Access Compliance Report Public Rights-of-Way (Curb Ramps)

Main Street: MAIN_ST Cross Street: N/A Location: NE

ADA ID: RPRK211026171858 Ramp Type: Type 4 - Parallel Initial Pass/Fail: Fail Overall Compliance: No Severity Score: 2

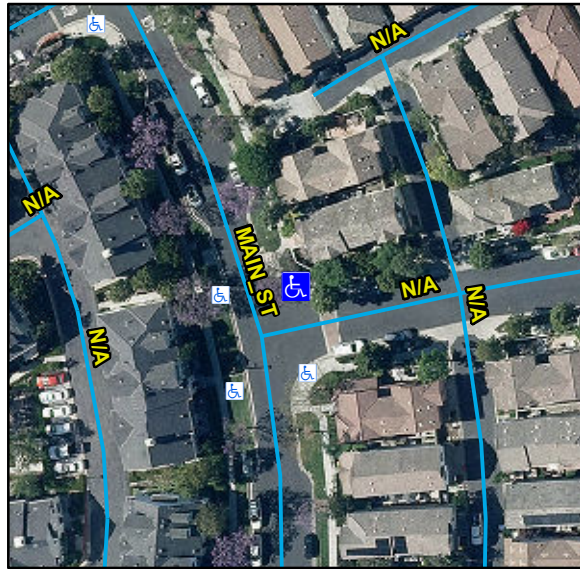
Compliance	Description	Data	Compliance	Description	Data
N/A	Ramp Length LT (in)	112	N/A	Ramp Length RT (in)	113
Yes	Ramp Width LT (in)	90	Yes	Ramp Width RT (in)	90
Yes	Ramp Run Slope LT (%)	6.3	Yes	Ramp Run Slope RT (%)	2.1
Yes	Ramp Cross Slope LT (%)	1.8	No	Ramp Cross Slope RT (%)	2.8
N/A	Landing Present	N/A	N/A	DWS Provided	N/A
N/A	Landing Length (in)	N/A	N/A	DWS Contrast	N/A
N/A	Landing Width (in)	N/A	N/A	DWS Length (in)	N/A
N/A	Landing Run Slope (%)	N/A	N/A	DWS Full Width	N/A
N/A	Landing Cross Slope (%)	N/A		DWS Offset Type	N/A
N/A	Landing Movement Obstructed?	N/A	N/A	DWS Offset Left (in)	N/A
	Landing Movement Type	N/A	N/A	DWS Offset Right (in)	N/A
N/A	Landing Shared	N/A			
N/A	Clear Space	Yes			
N/A	Clear Space To Crosswalk (in)	N/A			
N/A	Marked Crosswalk 1	No	N/A	Marked Crosswalk 2	No
	Crossing 1 Direction	W		Crossing 2 Direction	S
	Marked Crosswalk 1 Width (in)	N/A		Marked Crosswalk 2 Width (in)	N/A

Remove & Replace Curb Ramp With Two New Directional Ramps or Equivalent.
